**SITE PLAN REVIEW SHEET
ENVIRONMENTAL VARIANCE REQUEST ONLY**

CASE: SP-2019-0253C

PROJECT NAME: Springdale Farms

Staff Findings of Fact
Variance to LDC 25-8-261

Exhibit 1: Springdale Farms SP-2019-0253C – Overall Site Plan

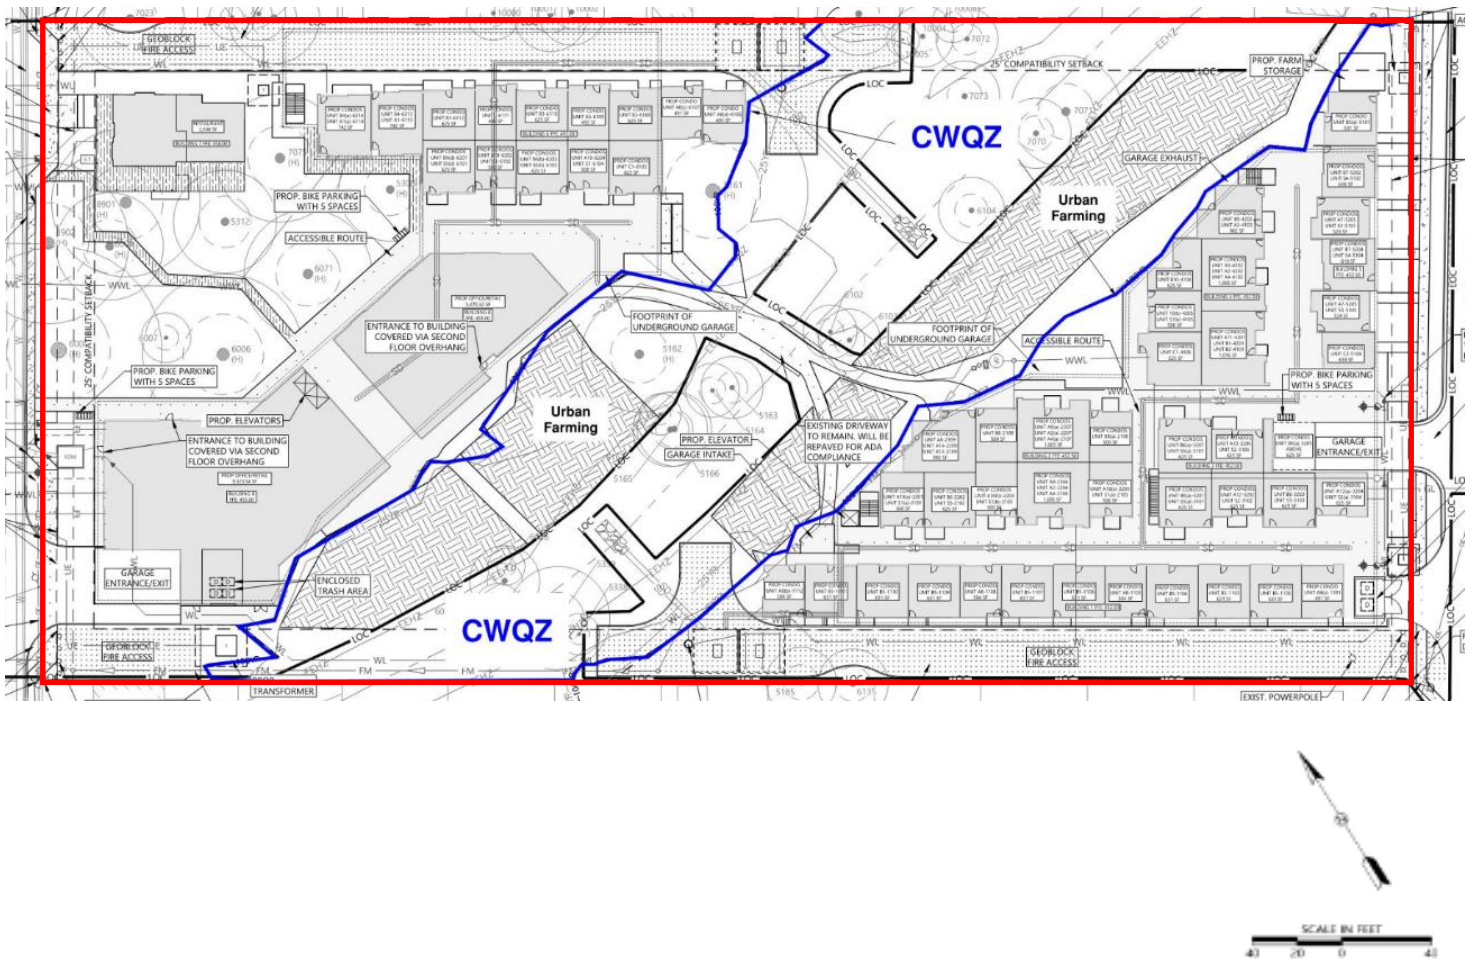
No Due to the scale of the project to maximize development, the applicant has made a design choice to make use of the CWQZ to address Austin Fire's code requirement for the hammerheads, which are not allowed by the Land Development Code. Moreover, to increase building square footage, there will be building overhangs over the CWQZ, creating rain shadow effect that would deprive the CWQZ of necessary rainfall and sunlight. The scale and design decisions do not provide greater overall environmental protection. See Exhibit 1 – Overall Proposed Site Plan.

- No In addition to the building overhangs within the CWQZ, the hammerheads encroach on both sides of the CWQZ. Development is prohibited within the CWQZ except as provided in LDC 25-8-261 which doesn't include the stated development, thus requiring the need for a variance from the Land Development Code.

- c) Does not create a significant probability of harmful environmental consequences.
- No The building overhangs and hammerheads within the CWQZ would deprive the CWQZ of rainfall and sunlight penetration that are necessary for riparian health, and adding impervious cover and development to the CWQZ where there wouldn't be otherwise. Furthermore, there would be removal of native vegetation and topsoil.

- 3. Development with the variance will result in water quality that is at least equal to the water quality achievable without the variance.
- No There would be impervious cover and development within the CWQZ where there wouldn't be otherwise. The impervious cover from the building overhangs would not be draining to the water quality pond.
